GLENORCHY PLANNING AUTHORITY

AGENDA

MONDAY, 31 OCTOBER 2016

5. PROPOSED USE AND DEVELOPMENT - PROPOSED BAKERY AND COFFEE PROCESSING (RESOURCE PROCESSING) AND TAKE AWAY FOOD PREMISES (FOOD SERVICES) WITH A VARIATION TO PARKING RELYING ON PERFORMANCE CRITERIA - 10 SUNDERLAND STREET, MOONAH

Figure 3. A snapshot of the proposal showing the privacy screen extending above the building envelope.

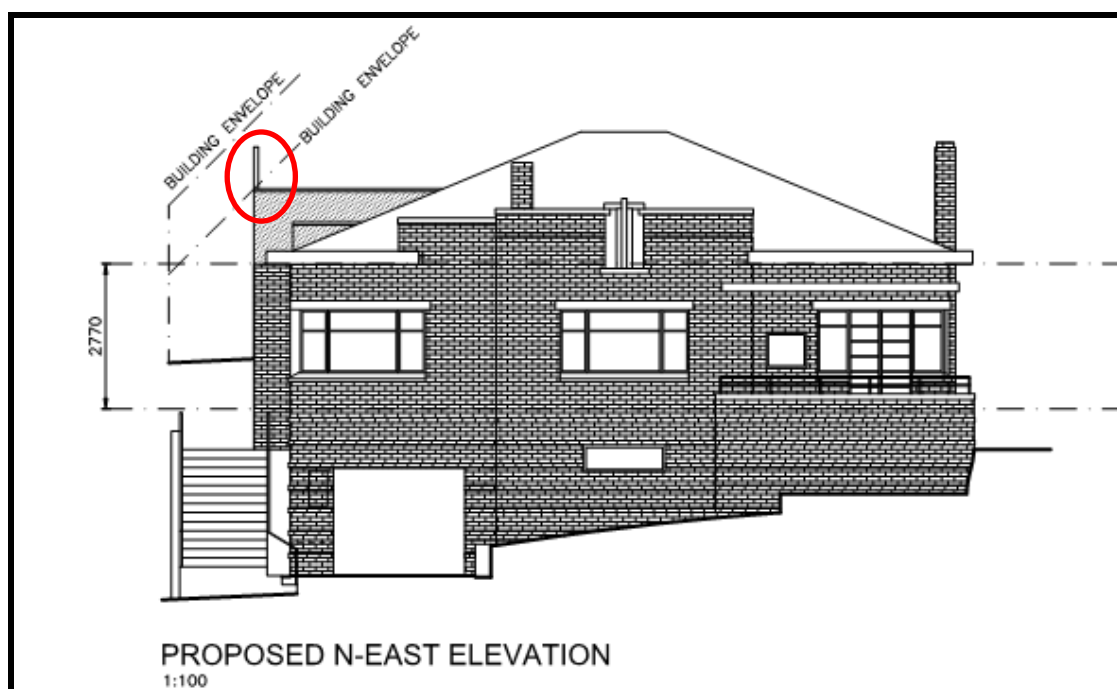
The proposed deck has a privacy screen which faces the south-eastern side boundary. The privacy screen extends outside the building envelope prescribed in acceptable solution A3 (Fig. 3).

The proposal is assessed as satisfying the performance criteria and complies with the standard.

Figure 4. A snapshot of the shadow diagram, showing the extent of the potential shadow cast over the adjoining property.

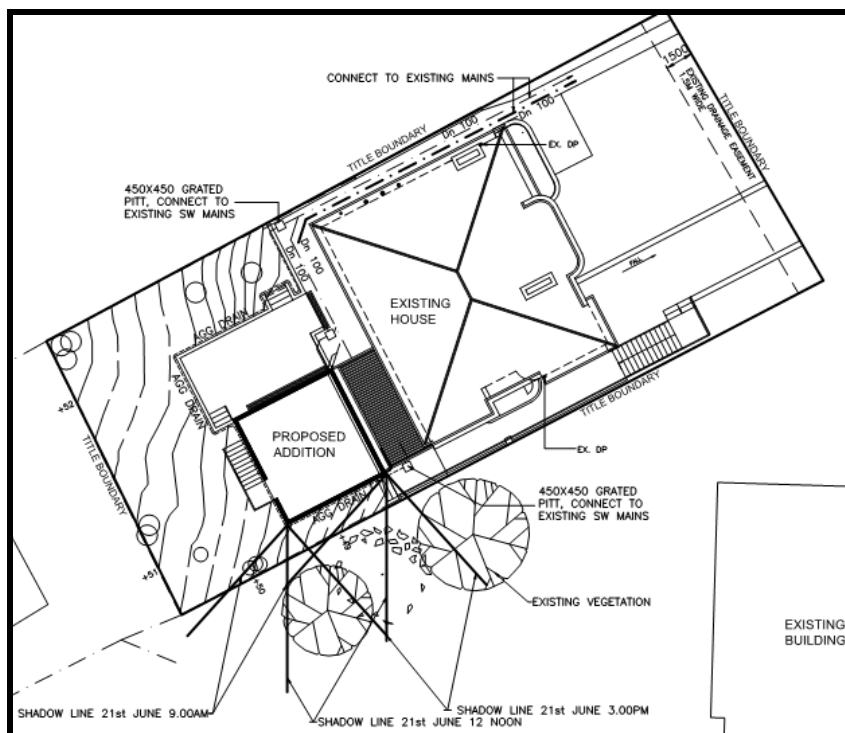
A shadow diagram demonstrates the extent of the potential shadow cast over the adjoining property (Fig. 4).

The shadow diagram indicates that the proposal would not cause a reduction in sunlight to a habitable room of the adjoining dwelling and would not unreasonably overshadow the private outdoor space of that dwelling. This is because the extent of the potential shadow cast is limited to less than half of the outdoor space and does not extend to the dwelling. This is attributed to the separation distance between the proposal and adjoining dwelling, which is compatible with that prevailing in the surrounding area.

Figure 5. A snapshot of the south-eastern elevation showing the extent of the proposal and the existing dwelling projecting above the boundary fence

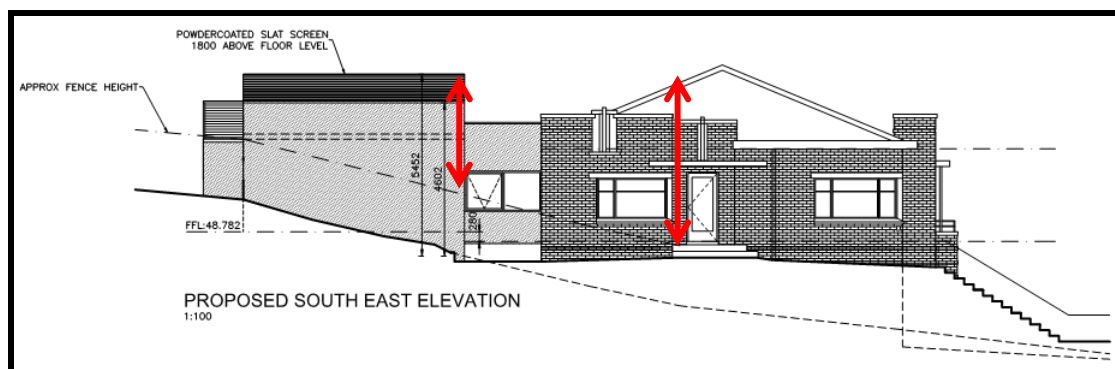
With respect to visual impact when viewed from an adjoining lot, the scale and proportions of the proposal are assessed as not causing an unreasonable impact to amenity given that the portion of the proposal extending above the boundary fence is less than the portion of the existing house that extends above the boundary fence. Therefore, it is reasonable to conclude that the proposal would have a lesser impact than that of the existing dwelling (Fig. 5).

Figure 6. A snapshot of the layout of the proposal, showing access to the private outdoor space via a study and hall way.

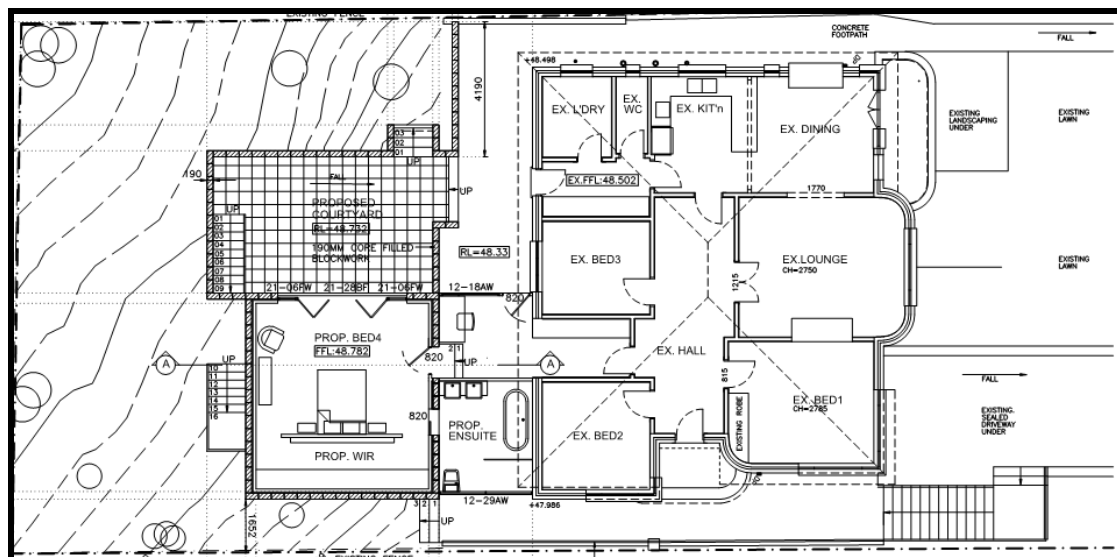
The proposal relies on performance criteria P2 as a result of the private outdoor space not having direct access from and adjacent to, a habitable room (other than a bedroom). The proposal has direct access to the private outdoor space from a study and hallway (Fig. 6).

The objective of the standard is to provide for outdoor recreation and the operational needs of the residents; and opportunities for the planting of gardens and landscaping; and private open space that is integrated with the living areas of the dwelling; and private open space that has access to sunlight. To achieve this, the performance criteria requires a dwelling must have private open space that includes an area that is capable of serving as an extension of the dwelling for outdoor relaxation, dining, entertaining and children's play that is conveniently located in relation to a living area of the dwelling; and orientated to take advantage of sunlight; unless the projected requirements of the occupants are considered to be satisfied by communal open space or public open space in close proximity.
